CHANNEL DISPLAY FOR A DJ-180T

This modification allows you to display the memory information by a channel number.

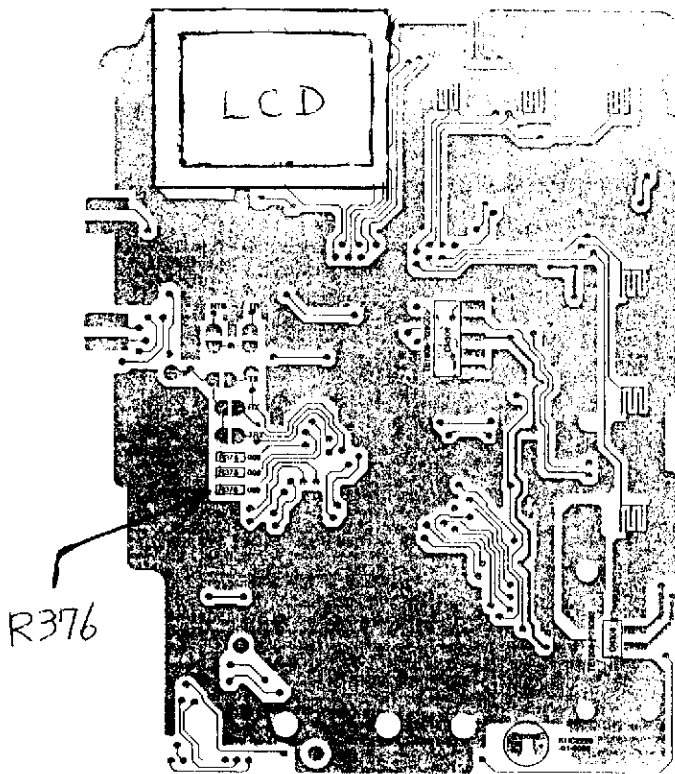
1. Remove the battery pack and the antenna.
2. Remove the battery terminal plate at bottom.
3. Remove two screws on the rear side of the unit.
4. Remove one small screw on the front case.
5. Remove the dial knob, squelch knob and volume knob.
6. Carefully open the unit.
7. Locate the R376 (chip resistor) on the control unit.
8. Carefully remove it with a soldering iron.
9. Reassemble the unit.
10. To display frequency, put the R376 back.
